Subject: USNRC Docket No. 72-1014, TAC L23657
HI-STORM 100 Certificate of Compliance 1014
HI-STORM License Amendment Request 1014-2, Revision 2, Supplement 3
Clarification of LAR Information

Enclosed please find the following revised documents comprising Supplement 3 to License Amendment Request (LAR) 1014-2, Revision 2. This supplement provides modified proposed changes to the HI-STORM CoC and FSAR that are required to correct the vacuum drying decay heat limit and bring it line with the previously approved value under CoC Amendment 1. The MPC vacuum drying evaluation for LAR 1014-2 has been re-performed to remove excess conservatism that was unreasonably punitive to the permissible heat load limit. The calculation of the effective thermal conductivity for the composite fuel basket walls during vacuum drying was over-conservative due to a combination of the methodology used and the assumption for the contents of the interstitial spaces (i.e., pure vacuum). A more realistic, but still conservative evaluation that recognizes the presence of low pressure (1 torr) water vapor in the interstitial spaces has been performed. Updated threshold decay heat loads for vacuum drying reported

FIGURE 4.4.7; RESISTANCE NETWORK MODEL OF A "BOX WALL-NEUTRON ABSORBER-SHEATHING" SANDWICH

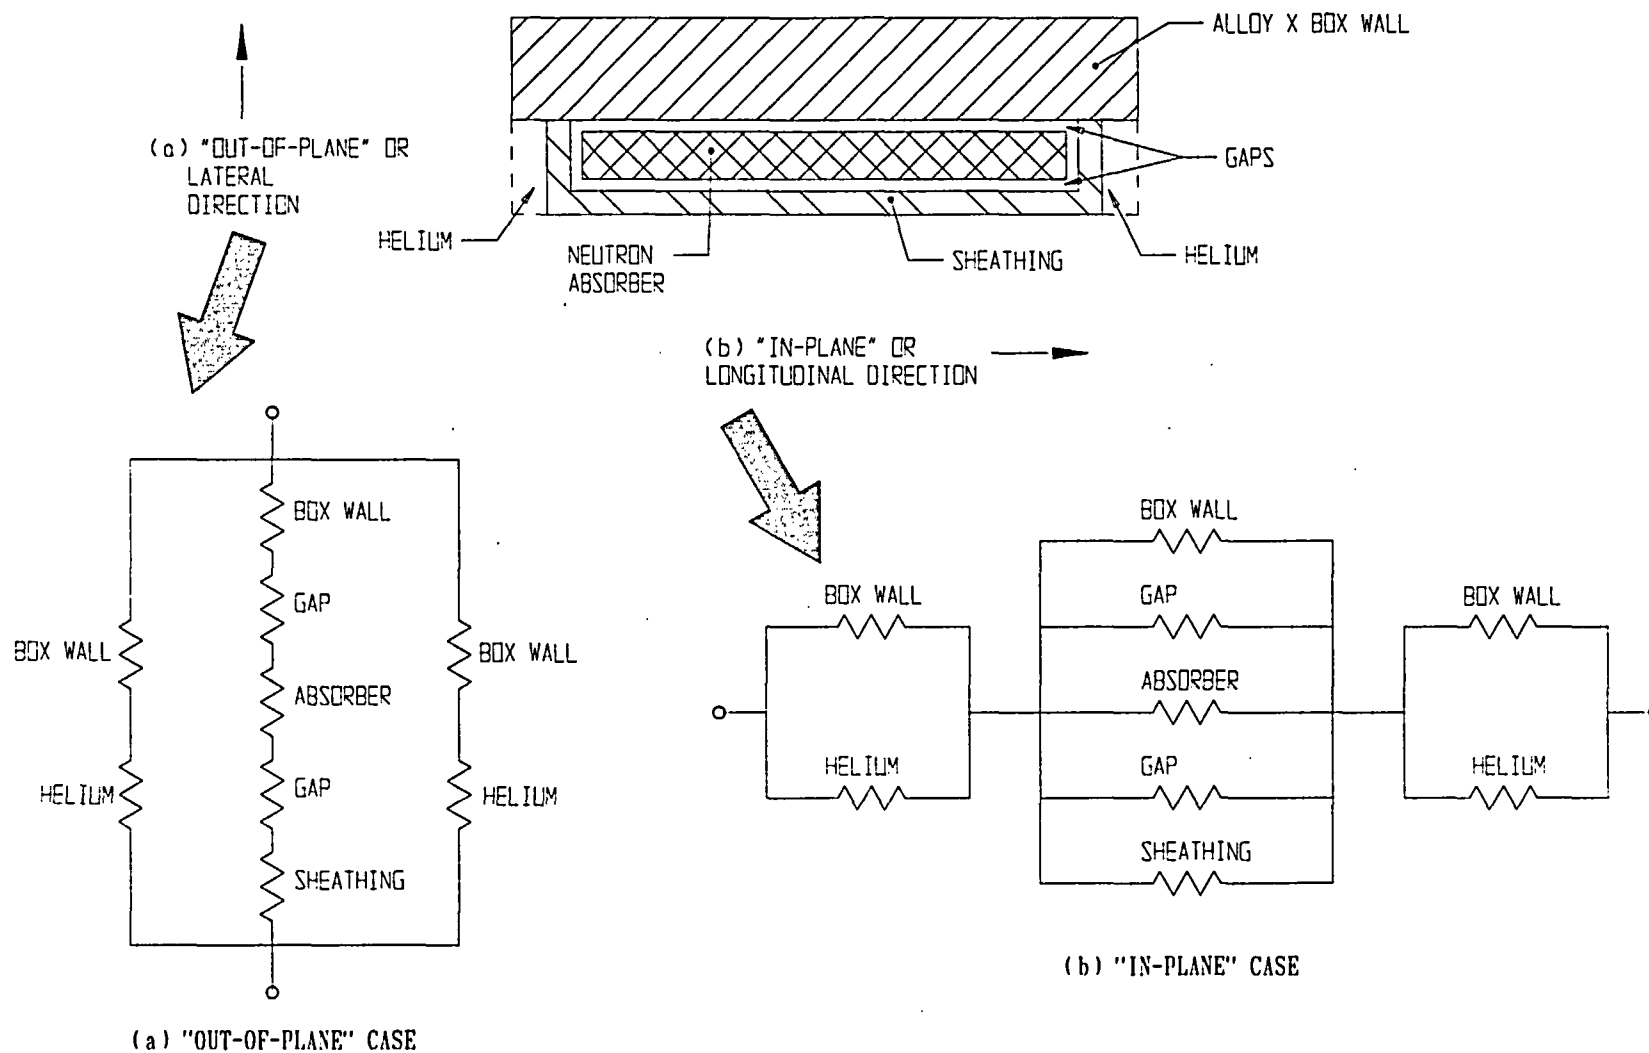
7. Remove FSAR page 4.4-45/46, Proposed Rev. 2C and replace with enclosed FSAR page 4.4-45/46, Proposed Rev. 2D.
8. Replace FSAR Figure 4.4.7, Proposed Rev 2B and replace with enclosed FSAR Figure 4.4.7, Proposed Rev. 2D.
